UFP2-80-110

Westinghouse Electric Corporation

July 8, 1980

QUESTIONS AND RESPONSES RELATED TO PRATTVILLE ER  
- NUCLEAR FUEL FABRICATION PLANT -

Four Directional Elevation Views of the SNM  
Building at the ANFFP Site

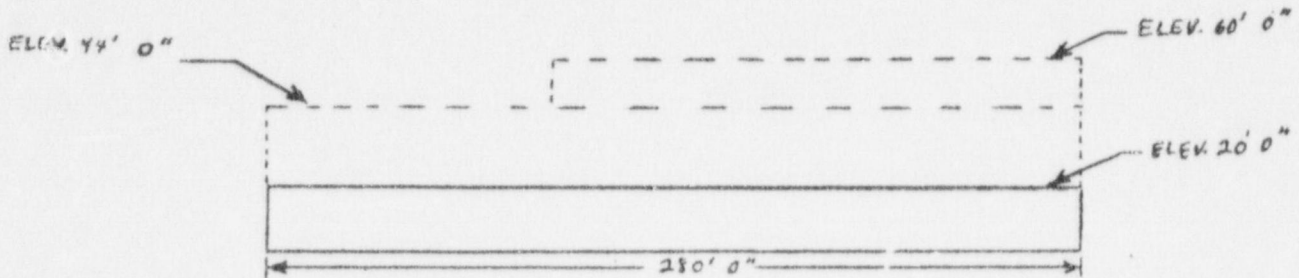
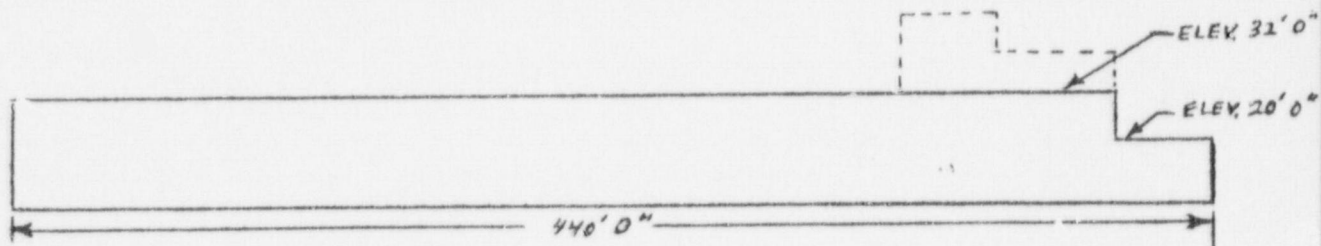
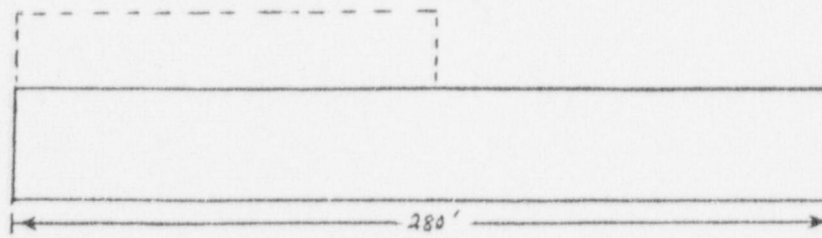
8. (ER: Section 2-6.3; p. 2-62 and 2-65; Section 6-3.1; p. 6-33; Meteorology)
- (a) Meteorological data are available from Dannelly Field from 1944 to date. Provide justification for using data from the time period 1956 through 1960 for calculation of dispersion factors.
  - (b) Why are the meteorological data from Dannelly Field (9 miles SSE of the site) expected to be more representative of the site than data from the Maxwell Air Force Base (6 miles ESE of the site)?
  - (c) Provide atmospheric dispersion factors for accidental and annual average releases using the appropriate stack release heights or ground-level release including building-wake effect; state all assumptions. Provide the plant's building dimensions.

- c. Alternate atmospheric dispersion factors for short term and annual average release conditions are provided in alternate tables (Attachments 8.1 through 8.10). The factors, as originally submitted, were based on ground level release with building wake effects considered, and, with a very conservative terrain recirculation correction factor included. These alternate factors are also based on ground level release with building wake effects considered; however, the terrain recirculation correction factor has been omitted - more in accord with Regulatory Guide 1.111, Revision 1, recommendations. (The net effect of this less conservative approach is to reduce the concentration per unit source strength ( $X/Q$ ) at the site boundary by a factor of four less than the original, very conservative, submittal.)

The current best estimate of the plant's building dimensions is submitted as Attachment 8.11.
